WYNNFIELD SUBDIVISION, UNIT FIVE, **RESUBDIVISION OF LOT 11**

APPLICATION NUMBER 7 DATE September 5, 2019
 APPLICANT Wynnfield Subdivision, Unit 5, Resubdivision of Lot 11
 REQUEST Subdivision

DETAIL SITE PLAN

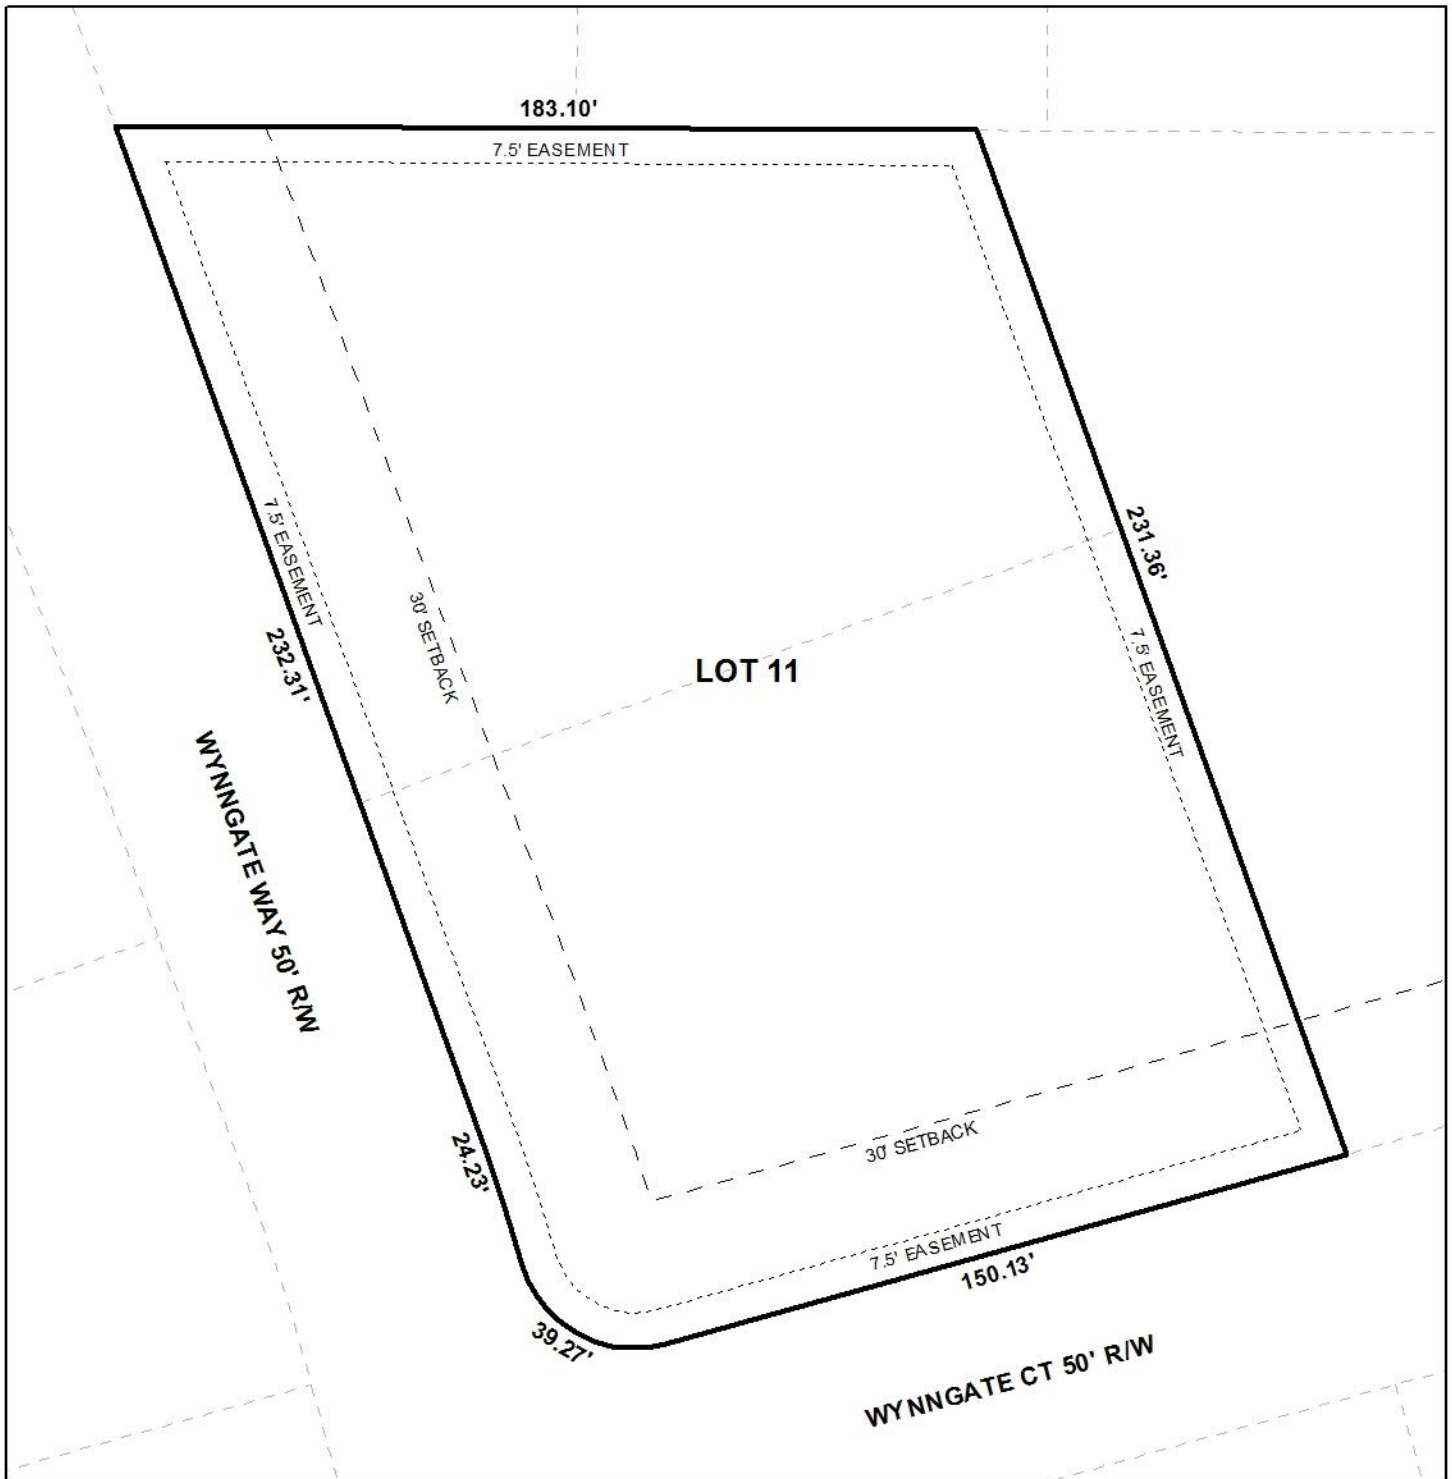
The subject site consists of Lot 12, Wynnfield Subdivision, Unit Five, approved by the Commission in October, 2015, and a portion of the Future Development area of that recorded subdivision. The Future Development area was shown with proposed lots and streets on the preliminary plat for Unit Five, but it was never developed or signed and thus expired. As the Future Development area has never been subdivided, but is still an existing tax parcel (R023303072000036), the remainder of the Future Development area must be included on the Final Plat as Future Development.

The site has frontage on Wynngate Court and Wynngate Way, both minor streets with compliant 50' rights-of-way. Therefore, no dedication would be required. As on the preliminary plat, the 30' minimum building setback line recorded with Wynngate Subdivision, Unit Five, should be retained on the Final Plat.

As on the preliminary plat, the lot size label in both square feet and acres should be retained on the Final Plat, or a table should be furnished on the Final Plat providing the same information.

The preliminary plat indicates easements along all boundaries of the site. Therefore, a note should be required on the Final Plat stating that no structure may be placed or constructed within any easement. Wynngate Subdivision, Unit Five, was recorded with Common Areas. Therefore,

a note should be required on the Final Plat stating that the maintenance of the Common Areas is the responsibility of the property owners.

As per the Traffic Engineering comments, the driveway number, size, location and design are to be approved by Traffic Engineering and conform to AASHTO standards. A note should be required on the Final Plat stating these comments.

- 1) revision of the plat to include the remainder of Tax Parcel R023303072000036 as Future Development on the Final Plat;
- 2) retention of the 30' minimum building setback line along Wynngate Court and Wynngate Way on the Final Plat;

- 3) retention of the lot size label in both square feet and acres on the Final Plat for proposed Lot 11, or the furnishing of a table on the Final Plat providing the same information;

- 4) revision of the plat to label the Future Development area in both square feet and acres, or the furnishing of a table on the Final Plat providing the same information;

- 5) placement of a note on the Final Plat stating that no structure may be placed or constructed within any easement.
- 6) placement of a note on the Final Plat stating that the maintenance of the Common Areas is the responsibility of the property owners;
